Nuclear Management Company, LLC  
Point Beach Nuclear Plant  
6610 Nuclear Road  
Two Rivers, WI 54241

DOCKETS 50-266 AND 50-301  
SUPPLEMENT 10 TO APPLICATION FOR AMENDMENT TO  
FACILITY OPERATING LICENSE APPENDIX A:  
TECHNICAL SPECIFICATIONS IMPROVEMENT PROJECT  
RESPONSE TO RAI ON ITS SECTION 3.7  
POINT BEACH NUCLEAR PLANT, UNITS 1 AND 2

DOCKETS 50-266 AND 50-301  
RESPONSE TO REQUEST FOR ADDITIONAL INFORMATION  
TECHNICAL SPECIFICATIONS IMPROVEMENT PROJECT SECTION 3.7  
POINT BEACH NUCLEAR PLANT UNITS 1 AND 2

Figure 15.5.4-1

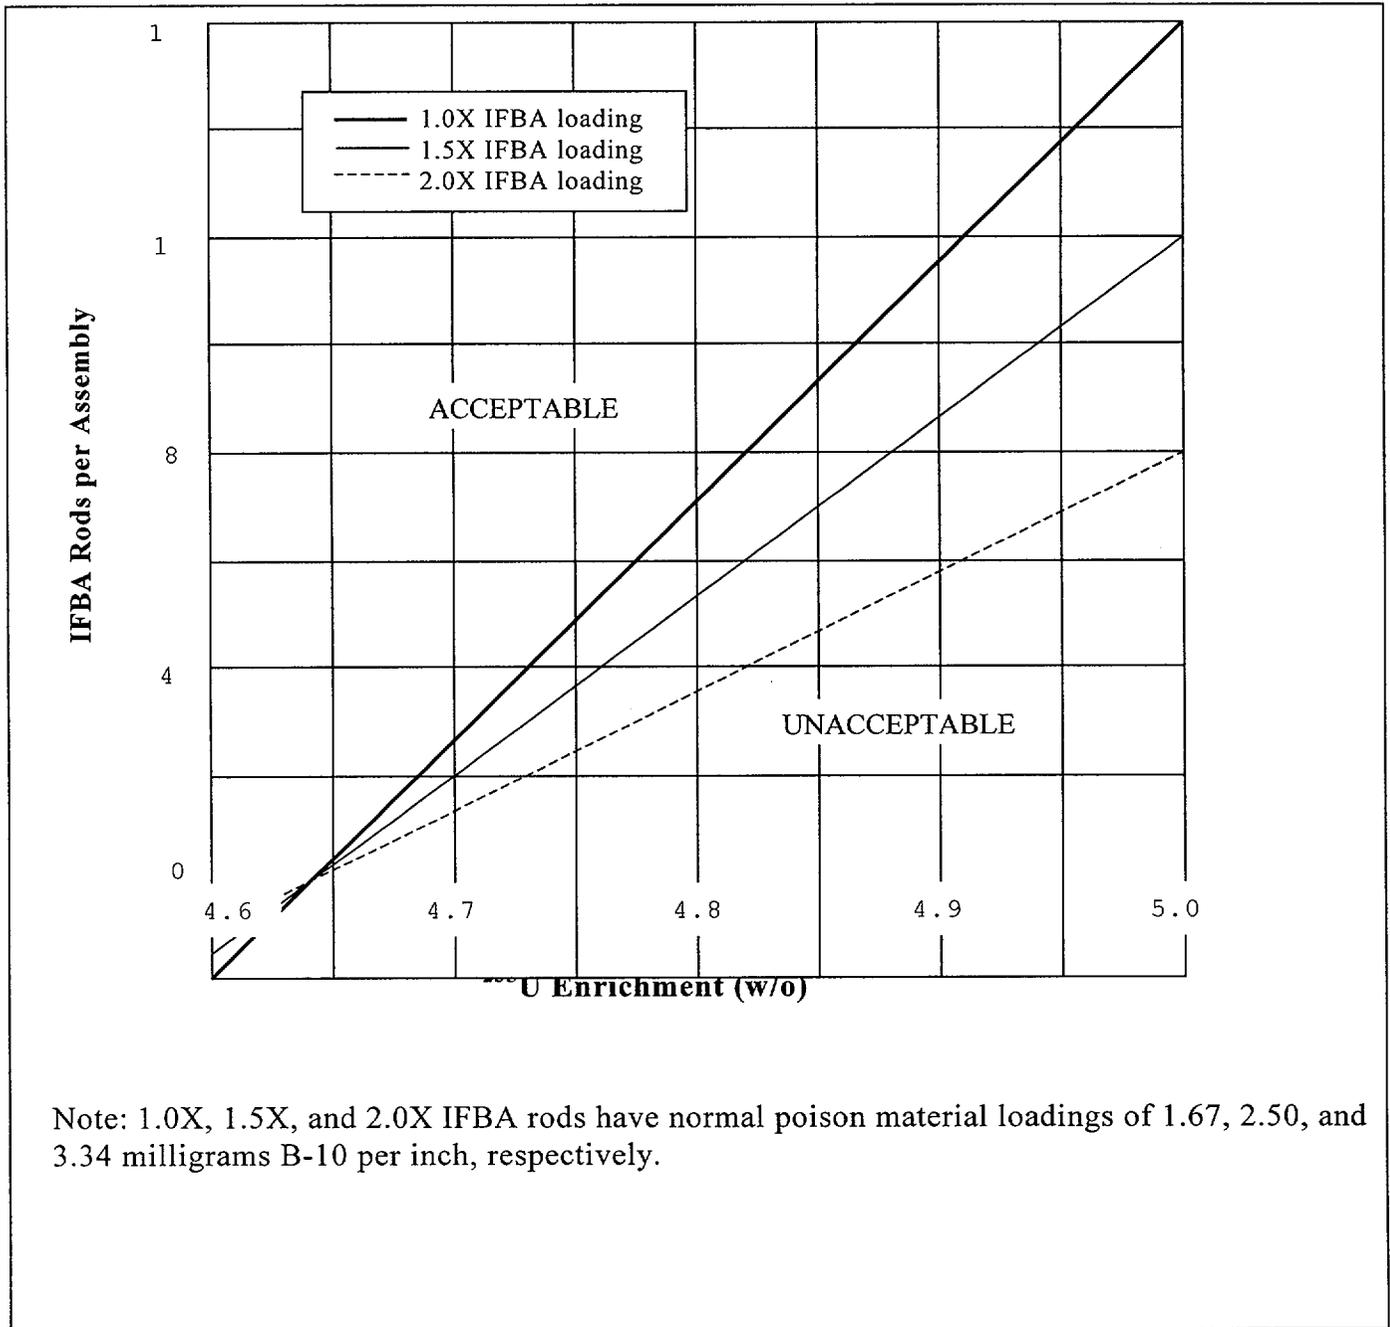
(3) The title from CTS Figure 15.5.4-1, "Fuel Assembly IFBA Requirements" must be retained for ITS Figure 3.7.12-1 because this figure only pertains to IFBA requirements and not to all "Fuel Assembly Storage Limits," as implied.

(3) The title for ITS Figure 3.7.12-1 has been changed to "Fuel Assembly IFBA Requirements." The revised title better describes the intent and limitations of the table and is consistent with the presentation of this information as it appears in the CTS.
